GENESEE COUNTY ROAD COMMISSION
Invitation to Bid
ITEM #115 – CONCRETE REPLACEMENT

ADDENDUM I

GENESEE COUNTY ROAD COMMISSION
Invitation to Bid
ITEM #115 – CONCRETE REPLACEMENT

BRINE TANK APPROACH
 8 INCH THICK

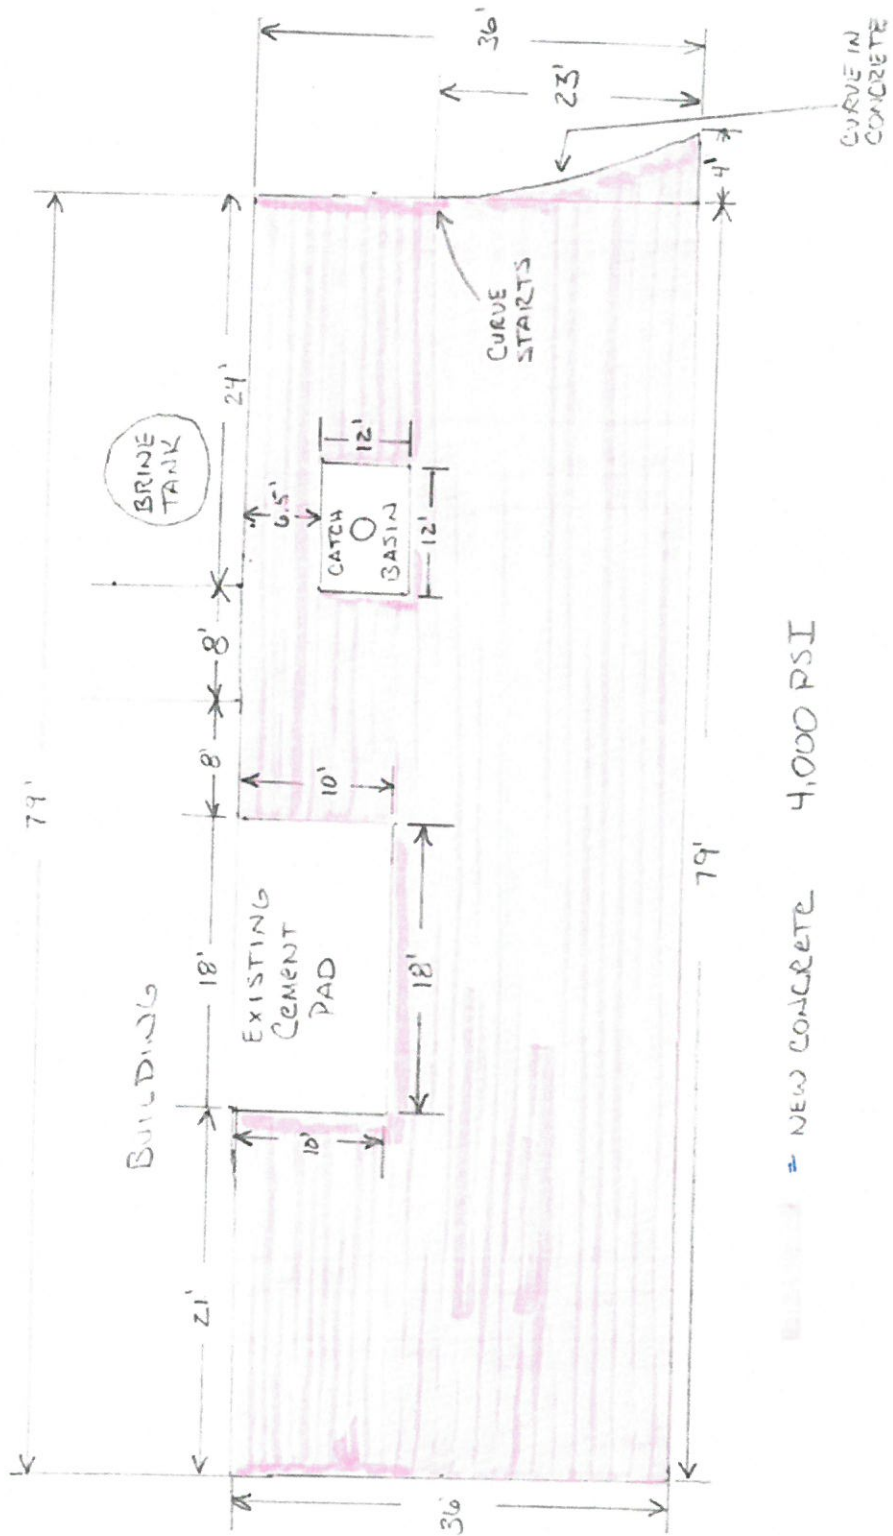
Brine Tank Approach (*Drawing Attached*) –

- Leave basin? **Yes, work up to/around pad**

- Do we want concrete right up to the pad around the tank? **Yes, we will pull the form around the tank, run concrete up to it. Put expansion joint between pad and building.**

- Rebar at the entrance to garage? **No**
